# Access Compliance Report

## Public Rights-of-Way

### (Curb Ramps)

Intersection ID: 44910	Main Street: FOX_POINT_DR	Cross Street: OAKBURN_DR	Location:	N
ADA ID: BD9AC547574C	Ramp Type: PerpDiag	Initial Pass/Fail: Fail	Overall Compliance: No	Severity Score: 17.5
Codes/Mitigation Info/Possible Solution		Field Measurements/Component Compliance

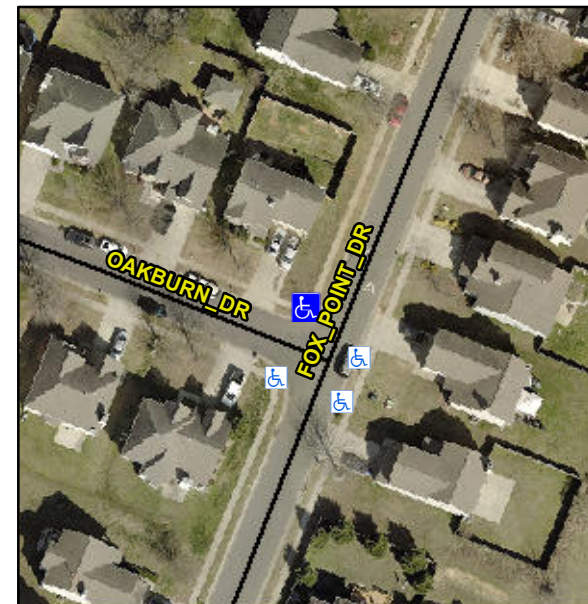
Compliance	Description	Data	Compliance	Description	Data
N/A	Ramp Length (in)	47.5	Yes	Ramp Slope (%)	7.8
No	Ramp Width (in)	35.0	Yes	Ramp XSlope (%)	0.5
N/A	Flare Type LT	N/A	N/A	Flare Type RT	N/A
N/A	Flare Slope LT (%)	N/A	N/A	Flare Slope RT (%)	N/A
N/A	Flare Traversable LT?	N/A	N/A	Flare Traversable RT?	N/A
N/A	Landing Length (in)	N/A	N/A	DWS Provided?	N/A
N/A	Landing Width (in)	N/A	N/A	DWS Contrast?	N/A
N/A	Landing Slope (%)	N/A	N/A	DWS Length (in)	N/A
N/A	Landing X Slope (%)	N/A	N/A	DWS Full Width?	N/A
N/A	Landing Curb? (Y/N)	N/A	N/A	DWS Offset (in)	N/A
N/A	Shared Landing?	N/A			
N/A	Gutter Ponding?	N/A	N/A	Gutter Slope (%)	N/A
N/A	Gutter Lip Ht (in)	N/A	N/A	Gutter X Slope (%)	N/A
N/A	Painted X Walk1?	No	N/A	Painted X Walk2?	No
	X Walk 1 Direction	To SW		X Walk 2 Direction	To SE
N/A	X Walk 1 Width (in)	N/A	N/A	X Walk 2 Width (in)	N/A
	X Walk 1 Slope (%)	1.6		X Walk 2 Slope (%)	0.9
	X Walk 1 X Slope (%)	0.1		X Walk 2 X Slope (%)	1.6

N/A	Ramp inside XWalk1?	N/A	N/A	Ramp inside XWalk2?	N/A
	Road Slope (%)	1.1	N/A	Clear Space?	N/A
	Road X Slope (%)	0.8	N/A	Clear Space to XWalk (in)	N/A
N/A	Any Obstructions?	N/A	N/A	Storm Grate/Utility Hazard?	N/A
	Obstruction Type			Storm Grate/Utility Type	
		N/A			N/A
			Yes	Surface Condition? (G/P)	Good

**Remove & Replace Curb Ramp With Two New Directional Ramps or Equivalent.**

**R304.5.1**
